Public Document Pack PLANNING COMMITTEE

18 **Late Observations**

Meeting of the Planning Committee – 13th March 2018

17/001450/FUL

Client		Project	
Outline Application for Housing Development at Manor Vale Lane, Kirbymoorside		Drawing	
Proposed Dwellings 1 to 6		Date	August 2016
Scale		1:100 @ A1	Drawn PAN
Status		PLANNING	Rev. C
Drawing No.		KWL/093/03/12

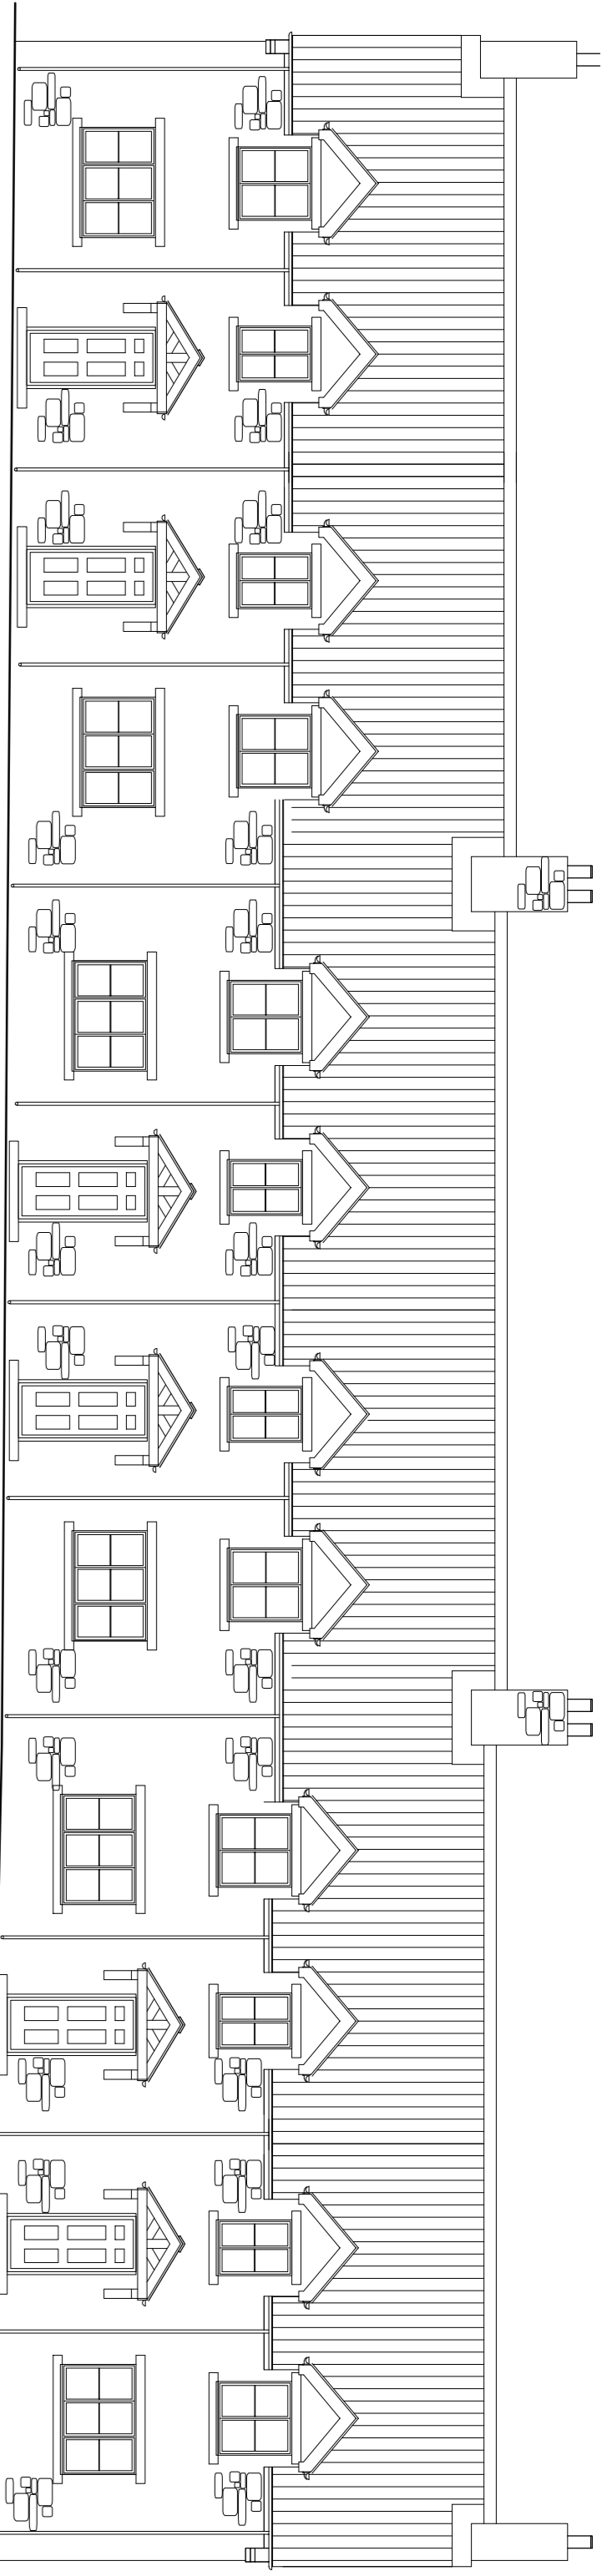
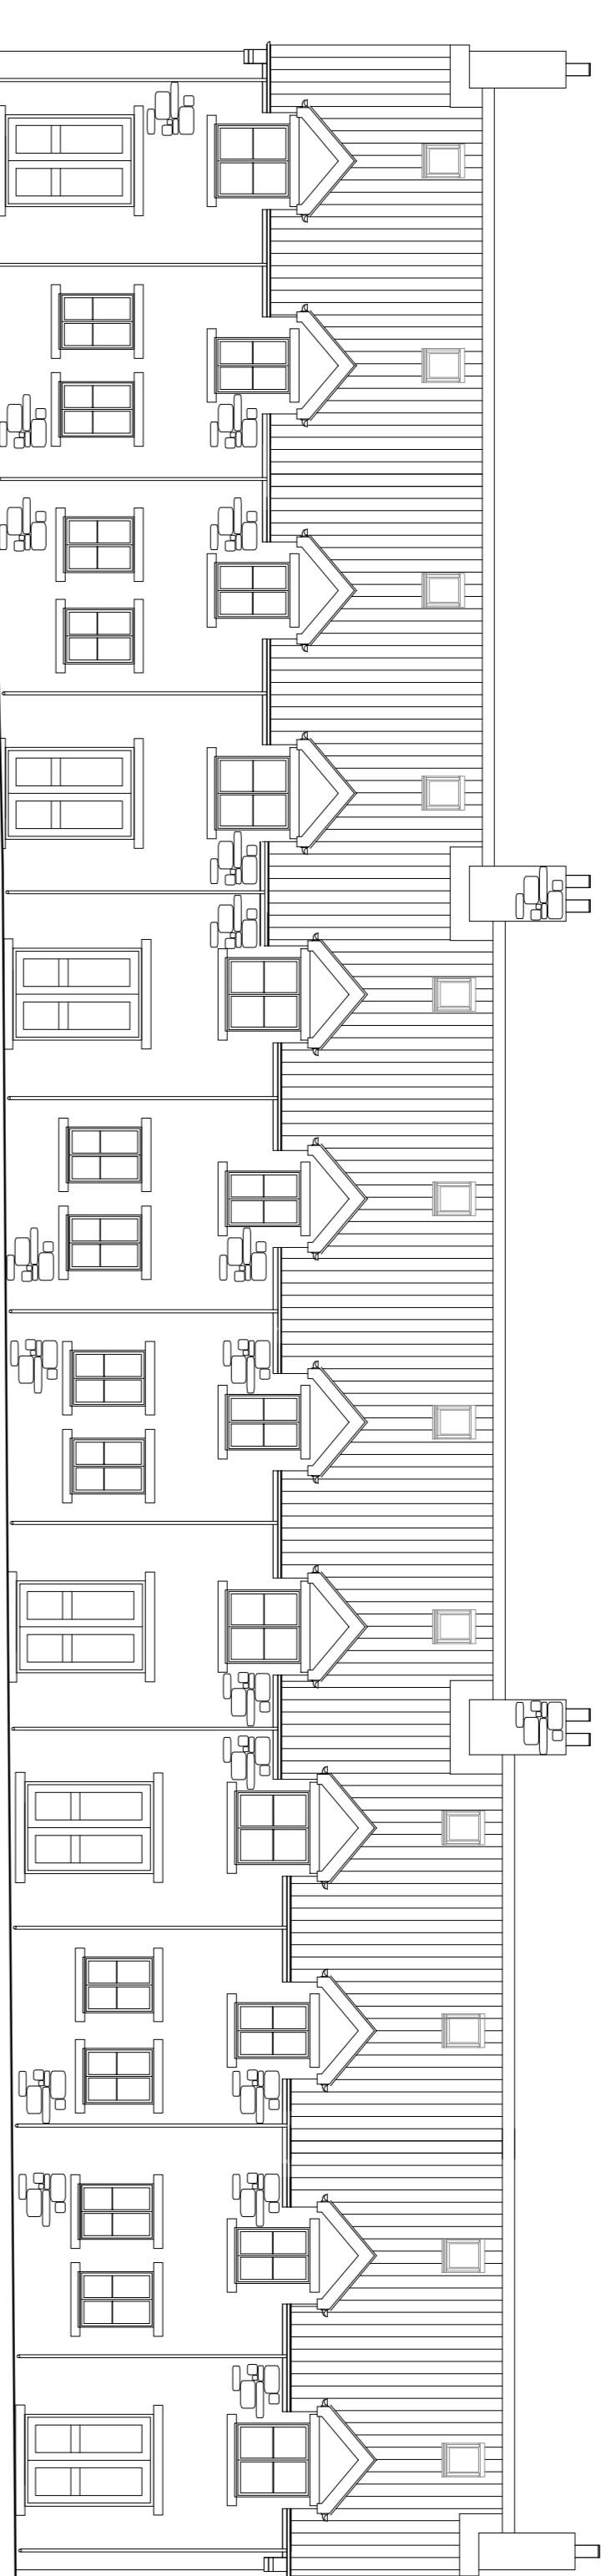
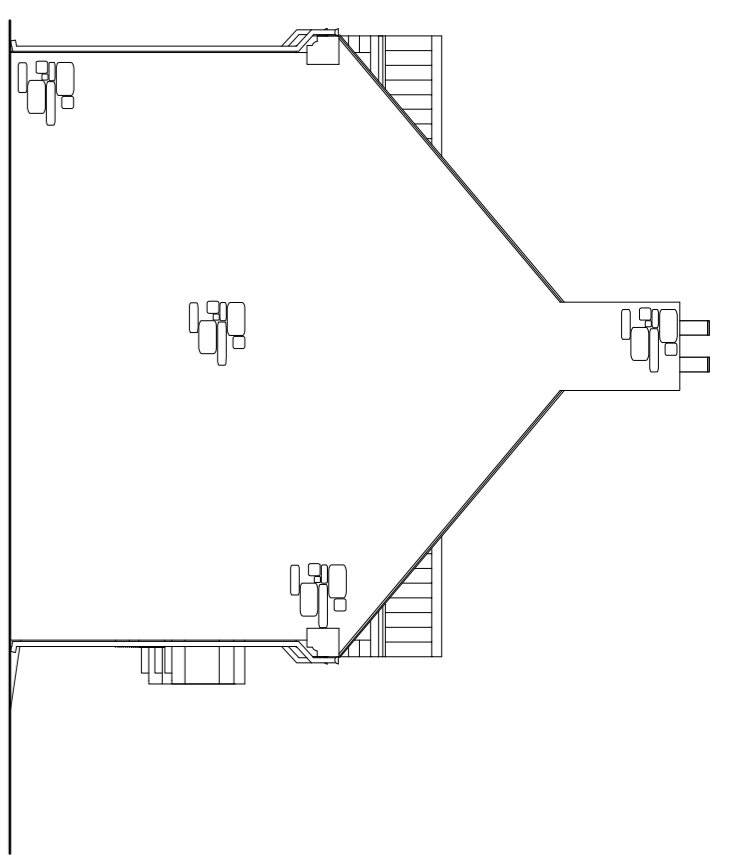
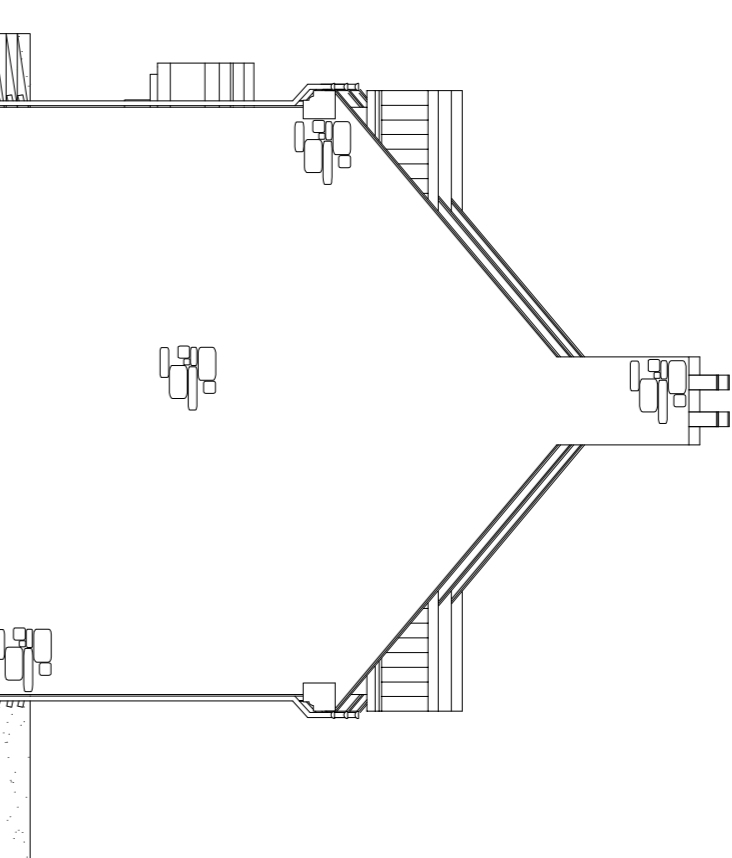
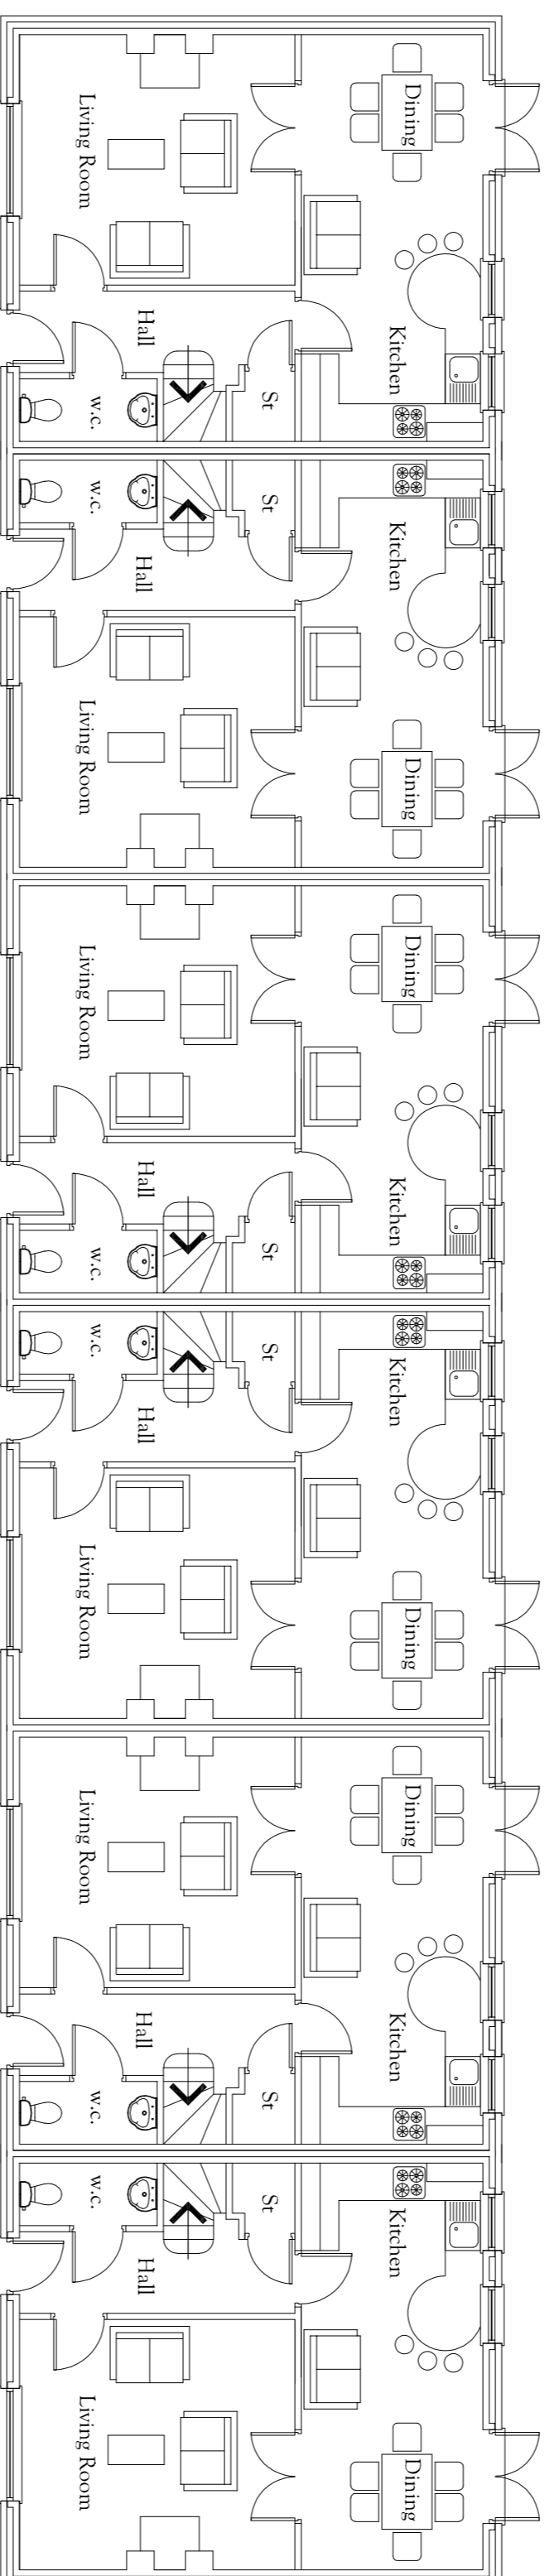
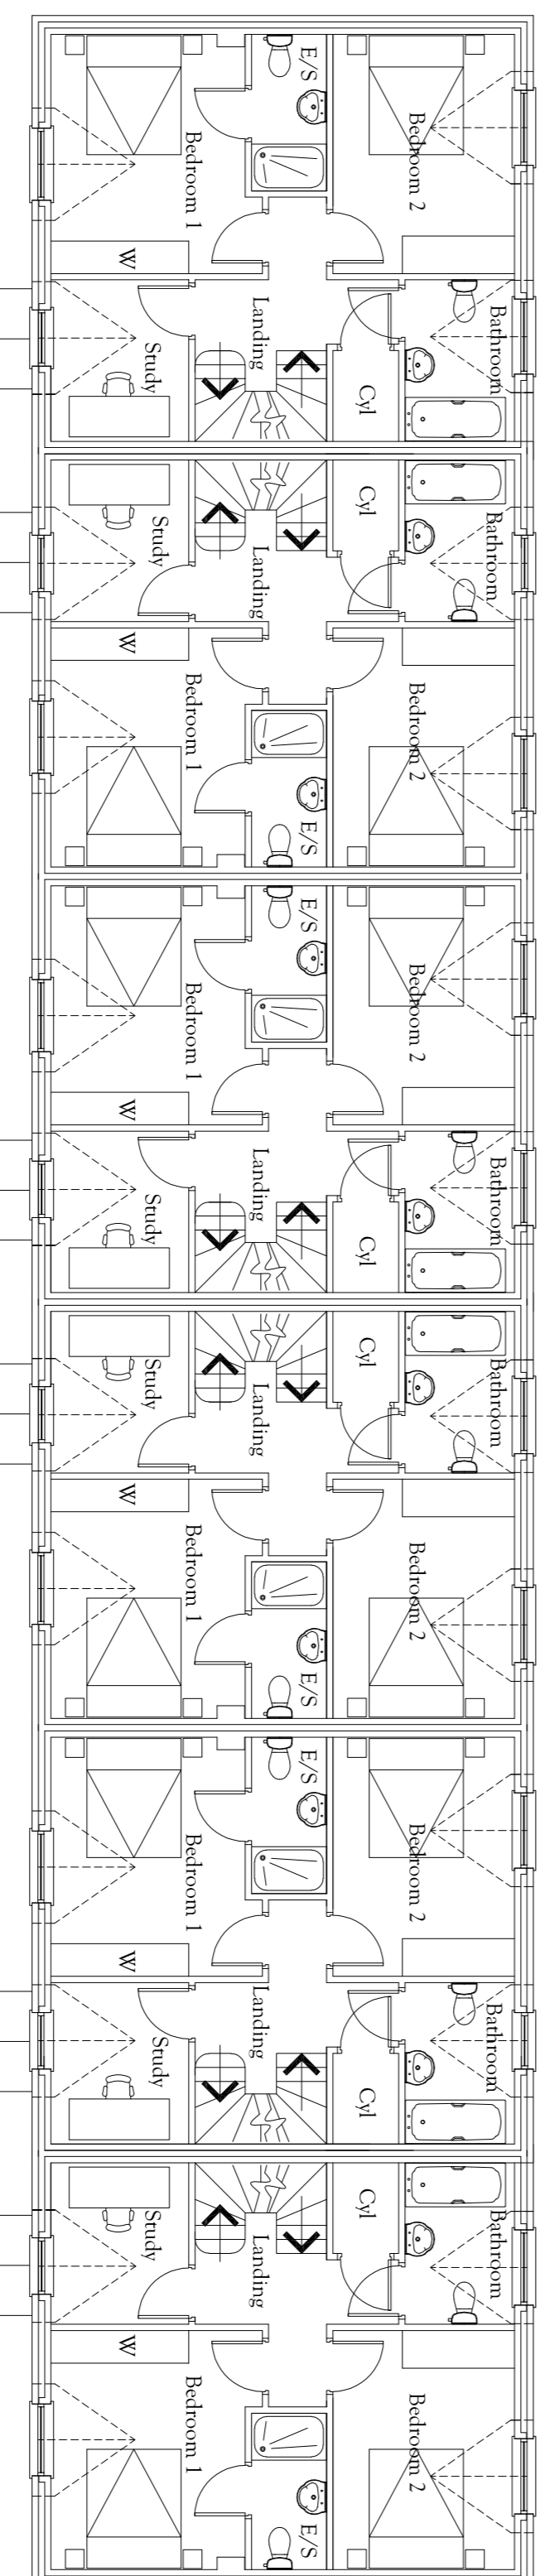
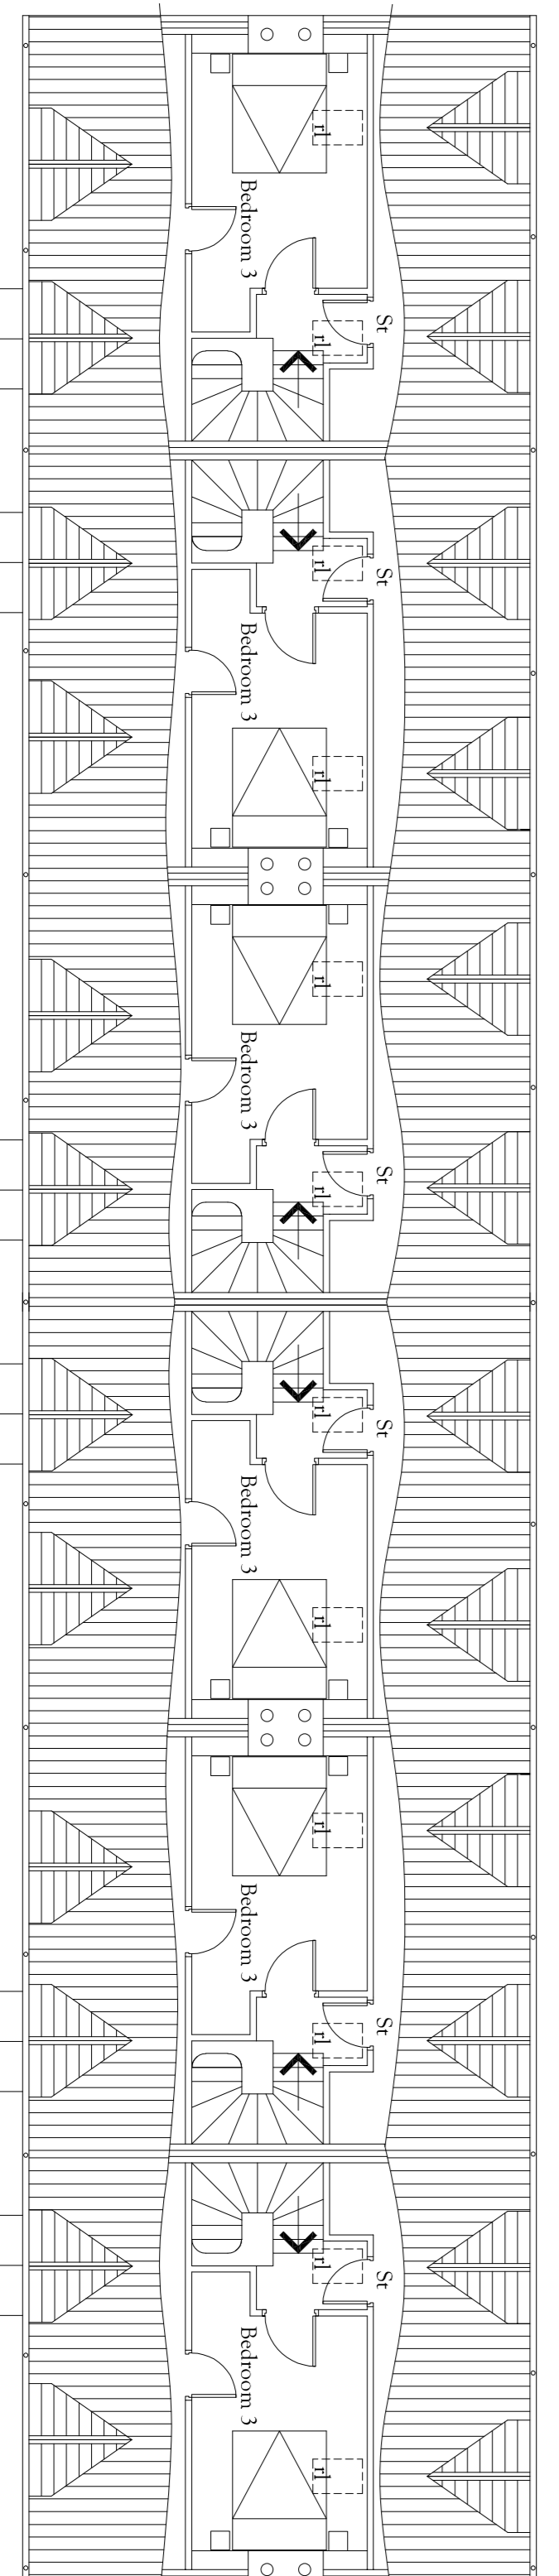
The agent has amended their application to revert to the original layout featuring habitable rooms on the front elevation facing the Band Hall. The revised layout plan is attached. This is unfortunate, especially after Officers engaged with the agent to try and reduce the noise from the Band Hall to the occupiers of the proposed dwellings through the amended layout. Nevertheless, the agent has asked that we determine the scheme with habitable rooms, including a living area, a bedroom, and a study that could also be used as a bedroom facing the Band Hall. Based on the advice of the Environmental Health Officer and the applicant's own Noise Assessment this unmitigated relationship cannot meet the noise standards used by the Local Planning Authority in accordance with Policy SP20 of the Local Plan Strategy. These standards are:

We have studied the Committee report for 13 March. Further to your comment on the outlook for residents in the proposed houses, we consider that the original floor plans provide a more satisfactory living environment for residents with the main living rooms in the front. This is in the light of YES, our acoustic consultants, concluding that, subject to the specified glazing being installed, residents will enjoy adequate internal noise control when the band is rehearsing, providing that their windows are closed.

Please find attached the Floor Plan and Elevations plan which was originally submitted with this application (KWL-093-03-12C). We would like this to replace Drawing KWL-093-03-12E submitted on February 21 which shows the living areas and bedrooms at the rear elevations of the properties.

2 PROPOSED WEST ELEVATION
Scale: 1:100

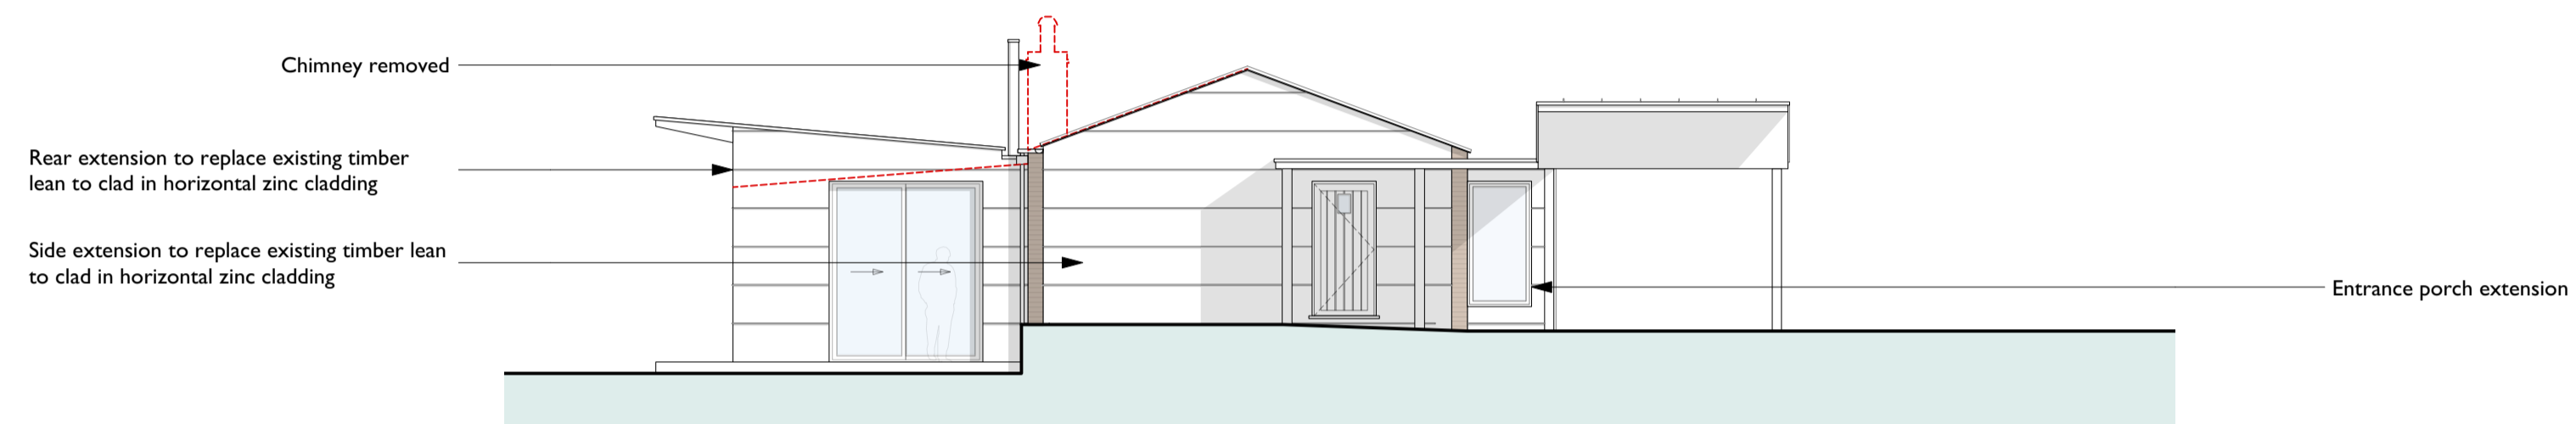
REVISION HISTORY			
REV	DESCRIPTION	DATE	APPROVED
A	West Elevation corrected	05/03/18	-
